<b>SERVICE BULLETIN</b>	
	<b>Flight Design GmbH</b> Sielminger Str. 51 D-70771 L.-Echterdingen Tel +49 (0)7021 / 80460-0 Fax +49 (0)7021 / 80460-69 E-Mail: <a href="mailto:airworthiness@flightdesign.com">airworthiness@flightdesign.com</a>	<b>SB-ASTM-CTLS-02</b> <b>Revision 00</b>
	Date of Initial Publication: <b>30-Nov-2009</b> Publication Date of this Revision: <b>30-Nov-2009</b>

## Rudder Centering Fork - Control Stop Replacement

### SB-ASTM-CTLS-02

Fig. 1

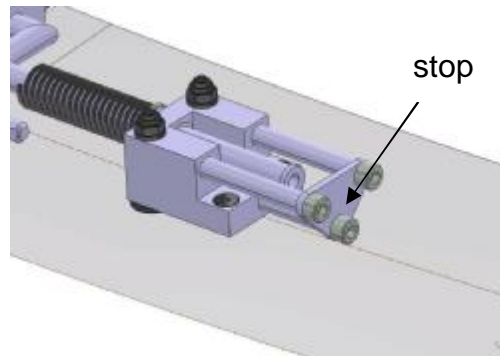
This is the rudder stop system that was installed to the CTLS affected by this SB ex factory. In this system the stop is provided to the rear end of the rudder centering fork, installed to the tunnel, below the instrument board. See following Fig. 1 and Fig. 2 for illustration.

This system is the system affected by this SB.

Fig. 3

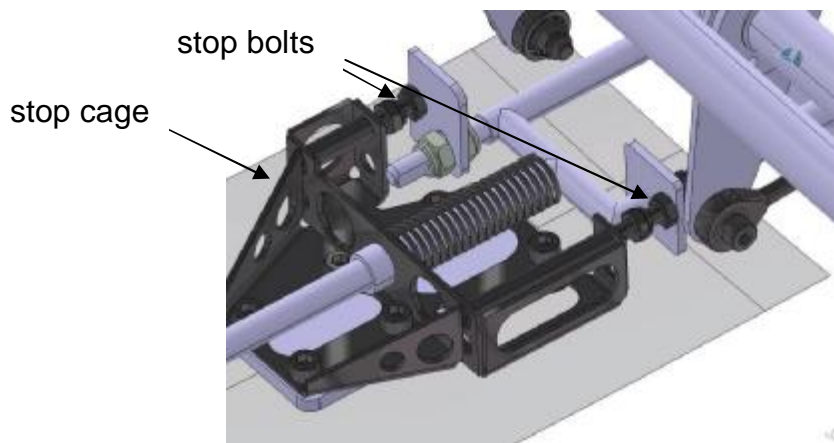
The new fork stop system provides a stop not to the rear end of the rudder centering fork, but to the thrust plates where the rudder centering fork contacts the bolt heads from the rudder pedal levers. The variant is clearly recognizable by the steel welded cage that provides the stops by means of adjustable bolts. See following Fig. 3 for illustration.

This stop device represents the valid type design and is used in serial production at the time of issuing of this SB. Only on aircrafts where the Rudder Stop Plates as by 3.1.3 cannot be used, this new fork stop system must be installed following SB [2].

Fig. 4

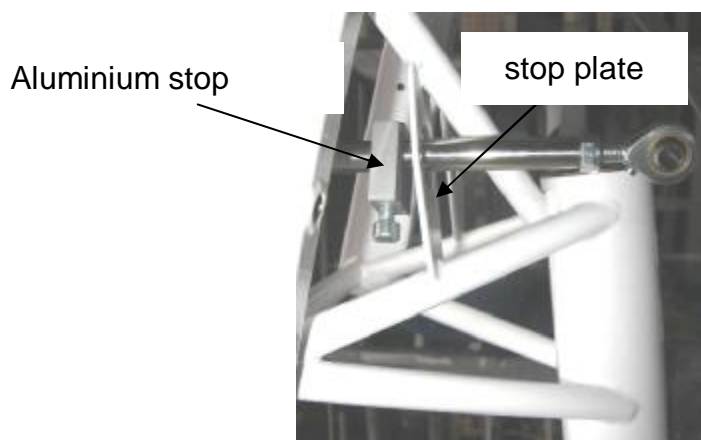
The rudder stop plates provide rudder stop not at the rudder centering fork. Aluminium stops, positioned to the control rods that connect the pedals with the nose gear steering, come to a stop against two stop plates welded to the big engine mount, in front of the firewall. See following Fig. 4 for illustration (only partially installed situation).

This stop device represents the valid type design previous to the introduction of the old fork stop system. It has been replaced in production due to the more complex adjustment principle, coupling with the rudder control rope pretension. On aircrafts where the welded stop plates are still available, this previous stop system shall be used again as it is easier and faster to be installed. The modification procedure is provided by this SB.

Fig. 11

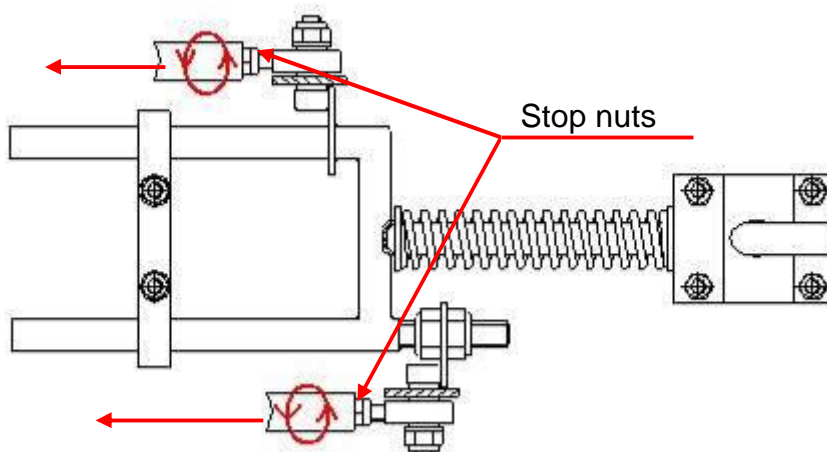
Unscrew pushrods from the cockpit side in the tunnel (Fig. 11). To loosen pushrods, hold self-locking stop nut on the rod end bearing with a suitable wrench. Do not change the position of the self-locking stop nut on the rod end as this will be the adjustment guide for the re-installation later.

Insert the pushrods back through the dust covers in the firewall. Thread the pushrods back to the stop nuts of the rod end bearings (that were left in position, see Fig. 11) on the cabin side of the firewall. After threading the pushrod back on, the rod end bearings on the engine side of the firewall must be aligned vertically, so that they match the nose wheel steering again. Tighten the stop nuts (Fig. 11) in this correct position.

Fig. 13

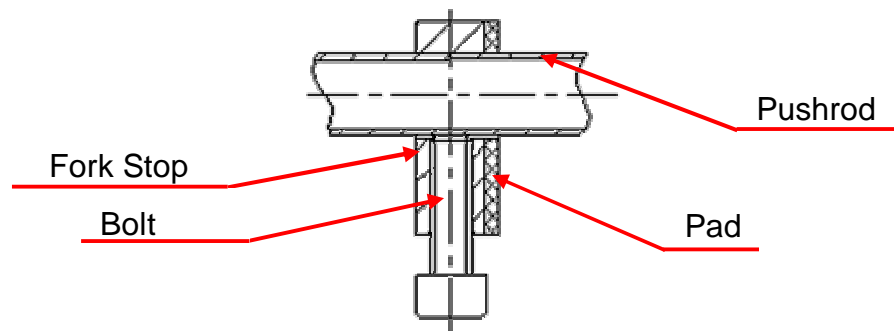
Loosely thread in the two (2) DIN 912 M6x20 bolts into the Aluminium stops, but do not tighten them yet before re-installation and adjustment (Fig. 13).

Fig. 14

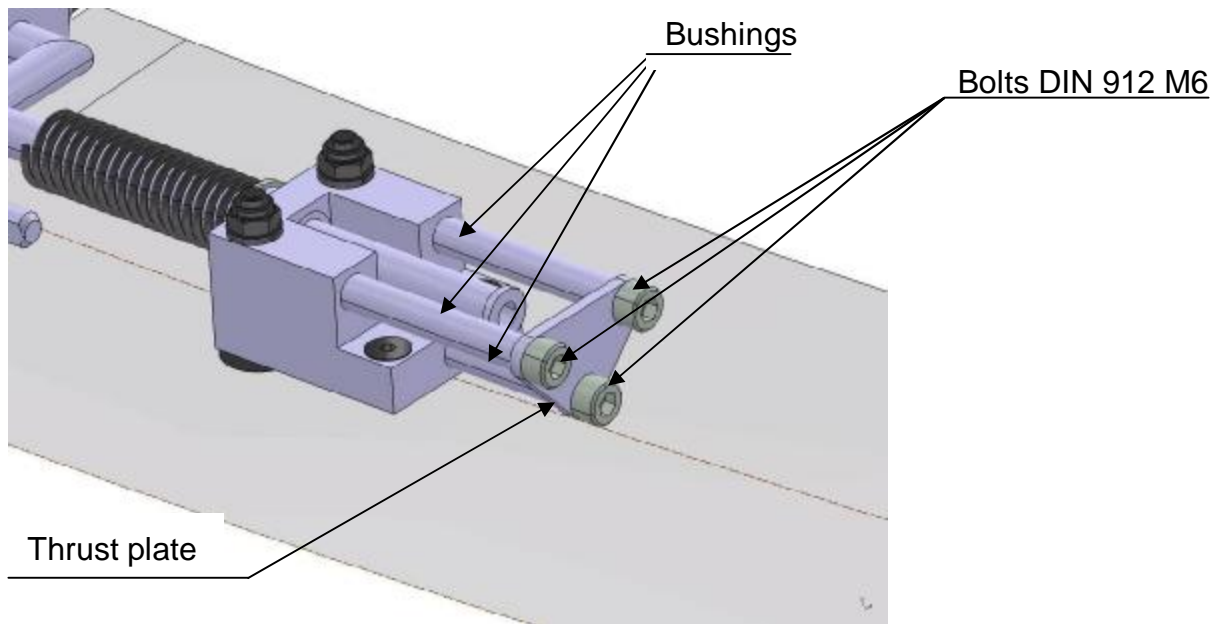
The old fork stop system, that guides the rear end of the rudder centering fork, must be uninstalled when the rudder stop plates are installed. To do this, remove the three bushings, bolts and thrust plate shown in Fig. 14 from the fork mount block. Unscrew three (3) DIN 912 M6 bolts (Fig. 14). Discard these parts.

Fig. 15

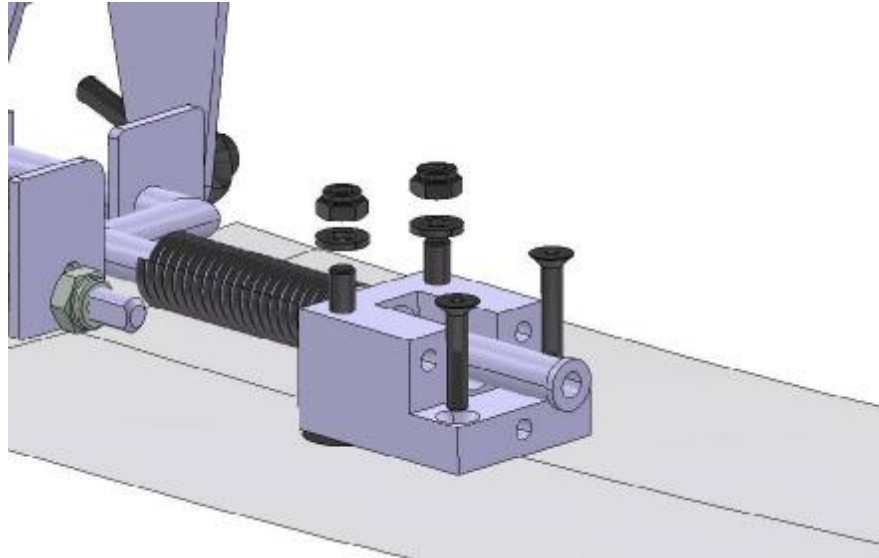
Remove the rear aluminum fork mount block from the lower fuselage skin by unscrewing the 4 bolts as shown in Fig. 15.

Make certain the position of the left side fork plate (Fig. 5 and Fig. 15, above, left side) is adjusted to the same position as on the original fork.

Fig. 16

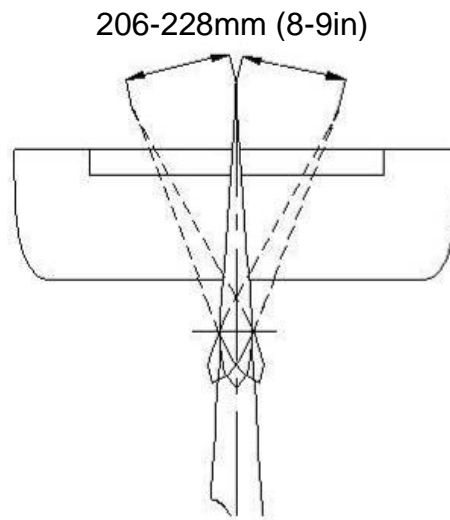
Maximum rudder deflection is measured at the lower trailing edge of the rudder as shown in Fig 16.
